Application for Amendment to Facility Operating License Credit for Soluble Boron in Spent Fuel Pool Rochester Gas and Electric Corporation R.R. Ginna Nuclear Power Plant Docket No. 50-244

The enclosed License Amendment Request (LAR) proposes to revise the Ginna Station Improved Technical Specifications (ITS) associated with the Spent Fuel Pool (SFP) Storage (LCO 3.7.13) and Design Features Fuel Storage (4.3).

Pursuant to Section 50.90 of the regulations of the U.S. Nuclear Regulatory Commission (the "Commission"), Rochester Gas and Electric Corporation ("RG&E"), holder of Facility Operating License No. DPR-18, hereby requests that the Improved Technical Specifications set forth in Appendix A to that license be amended. This request for change in Improved Technical Specifications is to revise the storage requirements contained within the Spent Fuel Pool (SFP) Storage (LCO 3.7.13) and Design Features Fuel Storage (4.3) specifications.

Subject: Application for Amendment to Facility Operating License
Ventilation Filter Testing Program Change (5.5.10)
Rochester Gas and Electric Corporation
R.E. Ginna Nuclear Power Plant
Docket No. 50-244

Figure B 3.7.13-1
Spent Fuel Pool

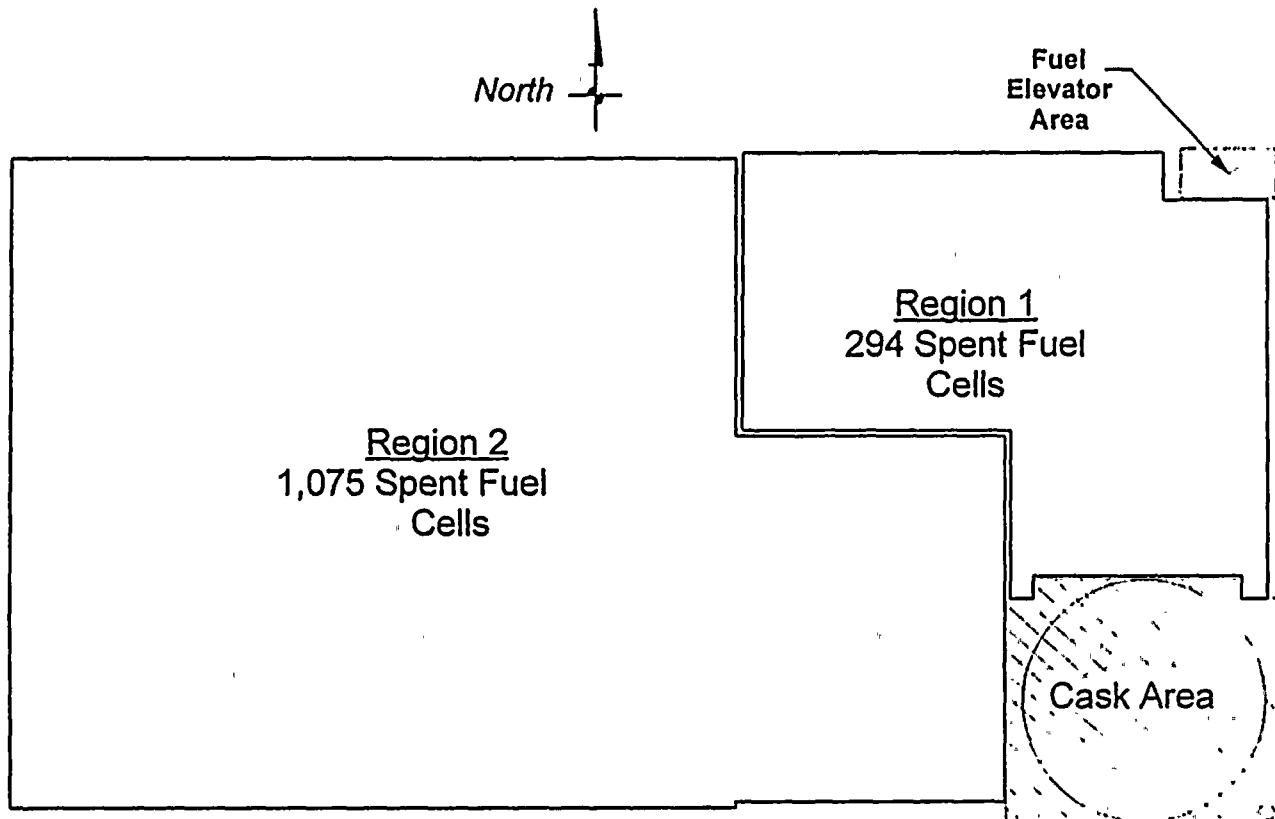
The spent fuel pool (SFP) is divided into two separate and distinct regions (see Figure B 3.7.13-1) which, for the purpose of criticality considerations, are considered as separate pools (Ref. 1). Region 1, with 294 storage positions, is designed to accommodate new or spent fuel utilizing a checkerboard arrangement. All fuel assemblies stored in Region 1 must have a k -infinity that is ≤ 1.458 . The existing design uses Integral Fuel Burnable Absorbers (IFBAs) as the poison for fuel assemblies with enrichments > 4.05 wt% to help achieve this k -infinity limit. IFBAs consist of neutron absorbing material which provides equivalencing reactivity holddown (i.e., neutron poison) that allows storage of higher enrichment fuel. The neutron absorbing material is a non-removable or integral part of the fuel assembly once it is applied. The infinite multiplication factor, K -infinity, is a reference criticality point of each fuel assembly that if maintained ≤ 1.458 , will result in a $k_{\text{eff}} \leq 0.95$ for Region 1. The K -infinity limit is derived for constant conditions of normal reactor core configuration (i.e., typical geometry of fuel assemblies in vertical position arranged in an infinite array) at cold conditions (i.e., 68°F and 14.7 psia). Fuel assemblies with minimum burnups above the curve in Figure 3.7.13-1 (area A) may be stored at any location within Region 1. Fuel assemblies with minimum burnups below the curve in Figure 3.7.13-1 (area B) may be stored in cells with lead-in funnels only.
